Technical Service Bulletin

SUBJECT:			No:	TSB-15-52A-001
			DATE:	February, 2015
- SERVICE MANUAL REVISION: REVISED			MODEL: See Below	
CIRCULATE TO:	[] GENERAL MANAGER	[] PARTS MANAGER		[X]TECHNICIAN
[X] SERVICE ADVISOR	[X] SERVICE MANAGER	[] WARRANTY PROCESS	OR	[] SALES MANAGER

PURPOSE

The lower front seat belt attaching method and the seat belt bolt tightening torque is incorrect in the 2011 – 2012 Outlander Sport service manual. The correct torque specification is $5.0 \pm 1.0 \, \text{Nm}$ (44 $\pm 8 \, \text{in/lb}$).

Please make the following changes to the 2006 Eclipse Service Manual, Group 52A – Interior —> Front Seat Belt —> Removal and Installation:

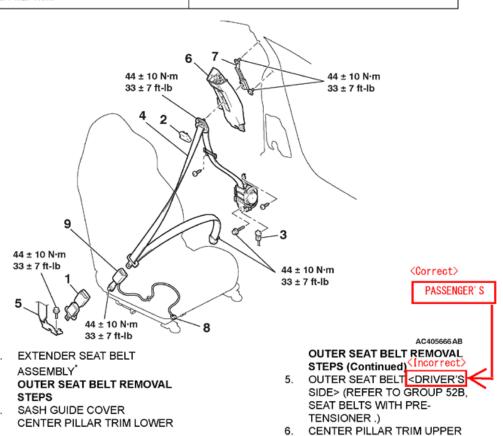
OUTER SEAT BELT <DRIVER'S SIDE> (REFER TO GROUP 52B, SEAT BELTS WITH PRE-

TENSIONER.)

Please make the following changes to the 2006 Lancer Service Manual, Group 52A – Interior —> Front Seat Belt —> Removal and Installation:

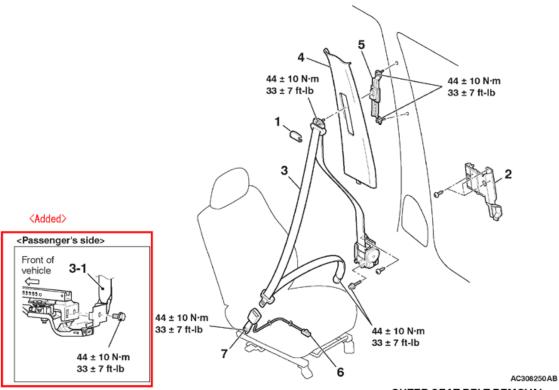
<Added>

3-1,OUTER SEAT BELT <PASSENGER'S SIDE> (REFER TO GROUP 52B, SEAT BELT WITH PRE-TENSIONER .)

Please make the following changes to the 2008 – 2010 Lancer Service Manual, Group 52A – Interior ––> Front Seat Belt ––> Removal and Installation:

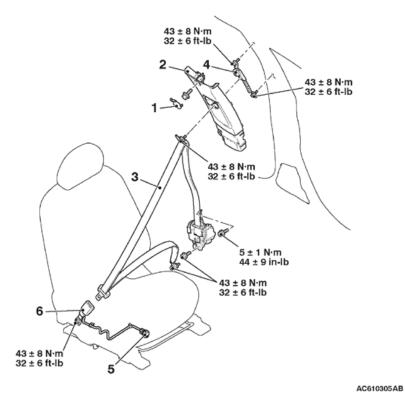
<Added>

<Added>

- 3-1.Outer seat belt <Passenger's side> (Refer to GROUP 52B, Seat Belt with Pre-tensioner).
- 4. Adjustable seat belt anchor

Please make the following changes to the 2009 – 2010 Lancer Sportback Service Manual, Group 52A – Interior ––> Seat Belt ––> Front Seat Belt ––> Removal and Installation:

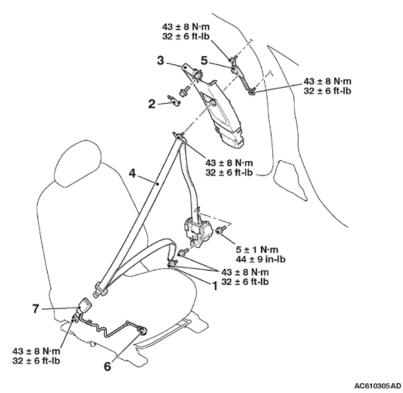
<Added>

- 4-1.Outer seat belt <Passenger's side> (Refer to GROUP 52B, Seat Belt with Pre-tensioner).
- Adjustable seat belt anchor Inner seat belt removal steps
- 6. Harness connector
- · Side shield cover.
- 7. Inner seat belt

Please make the following changes to the 2011 – 2015 Lancer / Lancer Sportback Service Manual, Group 52A – Interior —> Seat Belt —> Front Seat Belt —> Removal and Installation:

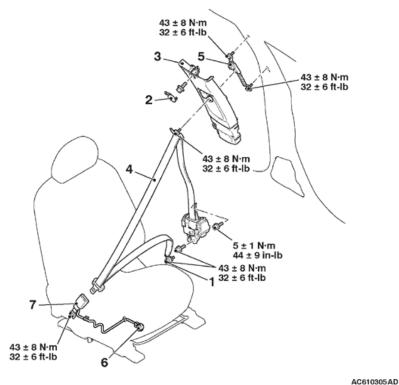
<Added>

Passenger's side>

<Added>

- 4-1.Outer seat belt <Passenger's side> (Refer to GROUP 52B, Seat Belt with Pre-tensioner).
- Adjustable seat belt anchor Inner seat belt removal steps
- 6. Harness connector
- · Side shield cover.
- 7. Inner seat belt

Please make the following changes to the 2008 – 2015 Lancer Evolution Service Manual, Group 52A – Interior ––> Seat Belt ––> Front Seat Belt ––> Removal and Installation:

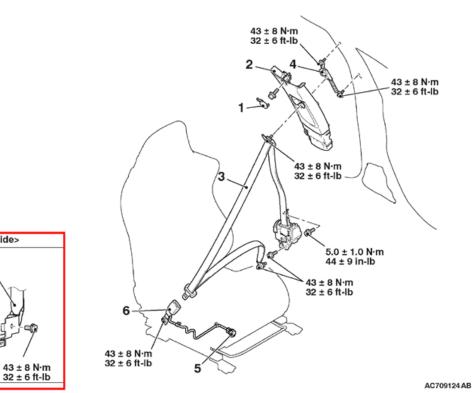
<Added>

<Passenger's side>

<Added>

- 3-1.Outer seat belt <Passenger's side> (Refer to GROUP 52B, Seat Belt with Pre-tensioner).
- Adjustable seat belt anchor

Please make the following changes to the 2007 - 2013 Outlander Service Manual, Group 52A -Interior --> Seat Belt --> Front Seat Belt --> Removal and Installation:

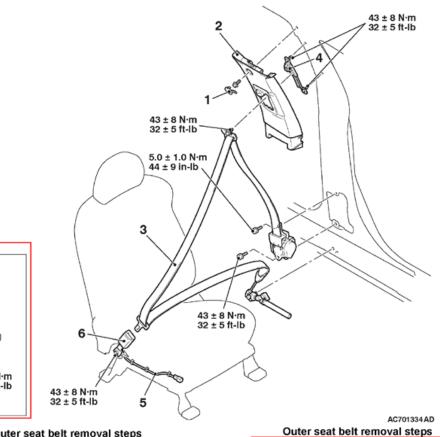
<Added>

- 3-1. Outer seat belt <Passenger's side>
